<u></u>	Appr	oved For R	elease i				30087	8RI	0060	0030005)-3	
LOC	KHEED AIRC	RAFT CORP.		,	ERING S				1,	A.C.	-93	
DATE	11-30-60			AFFECT	s:	W	/SPO	\mathbf{x}		PRO	JECT X	
NAME	OF MAJOR CO	OMPONENT	PART	OR LOW	EST SUBA	ASSEMB	LY		PAR	NO. &	MODEL OR	TYPE
O2 SYSTEM TITLE OF PROPOSAL: OXYGEN SYSTEM IMPROVEMENTS												
NATURE OF PROPOSAL:												
				SEE P	AGE 2							
2 . 3•	tation of indicated pressures.											
ES	ESTIMATED COST AND TIME INVOLVED : ADDITIONAL FUNDING REQUIRED :											
					se Page	a i						
CP	ADDITIONAL FUNDING REQUIRED: NONE (SP-1917)											
ITEMS	AFFECTED BY											
SAFET	Y MISSION EFFEC-	PERFORM-	OPERATING PROCEDURE	INTER- CHANGE-	WEIGHT O WEIGHT & BALANCE	SUPF	LS & PORT	MAII NAN PROCE	ICE	SERVICE LIFE	FLIGHT MANUAL	MAINTE- NANCE MANUAL
	TIVENESS			ABILITY	BALANCE)]			
EST. MAN/HRS. REQ'D. TO ACCOMPLISH CHANGE IN FIELD												
SOUR	CE OF PARTS	FOR KIT			A۱	/AILABI	LITY	17	\	WEEKS A	FTER APPRO	OVAL STATINT

NATURE OF PROPOSAL:

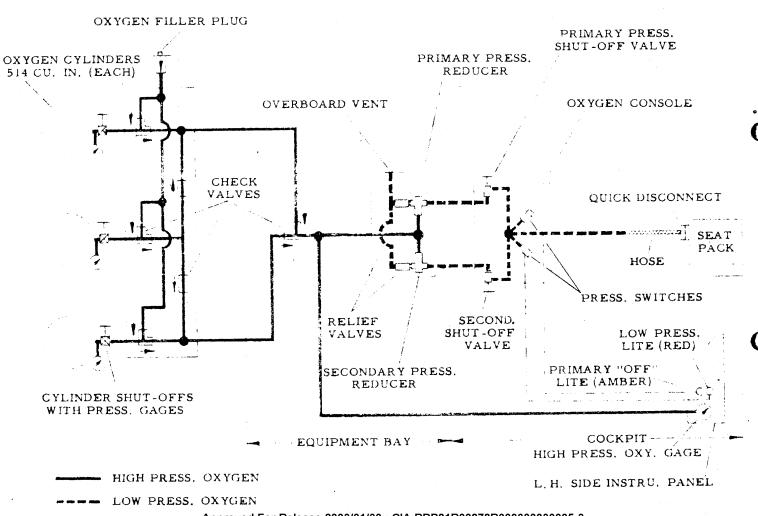
- 1. Modify all a craft (except 388/721 and 394/954)* as follows:
 - except the high pressure gage and the indicator lights in the L. H. side instrument panel. Replace the present Oxygen Console with a new Console Assembly (Lo-pressure only) which includes the two existing pressure switches, and two new slowopening needle valves for controlling the "primary" and "secondary" low pressure systems. (See Figure 1.)

- b. Q-Bay Install Box Assembly (dirt and grease shield) which includes new improved relief valves, and reworked pressure reducers.
 - NOTE: Existing pressure reducers will be reworked by removing the "on-off" handle, adding metal diaphragms and metal-to-metal seats. (Valve bodies will be unpainted aluminum on future production). The new relief valves will have a flow rating compatible, with system capacity and will be vented overboard.

- c. Oxygen Cylinders Remove the existing automatic opening cylinder valves and replace with slow opening needle valves and pressure gages on each cylinder.

- d. Modify plumbing to connect relocated system elements. Special fittings will be utilized to reduce to a minimum, the number of high and low pressure line connections. Revised installation procedure will require application of anti-sabotage paint to certify the security of each plumbing connection.
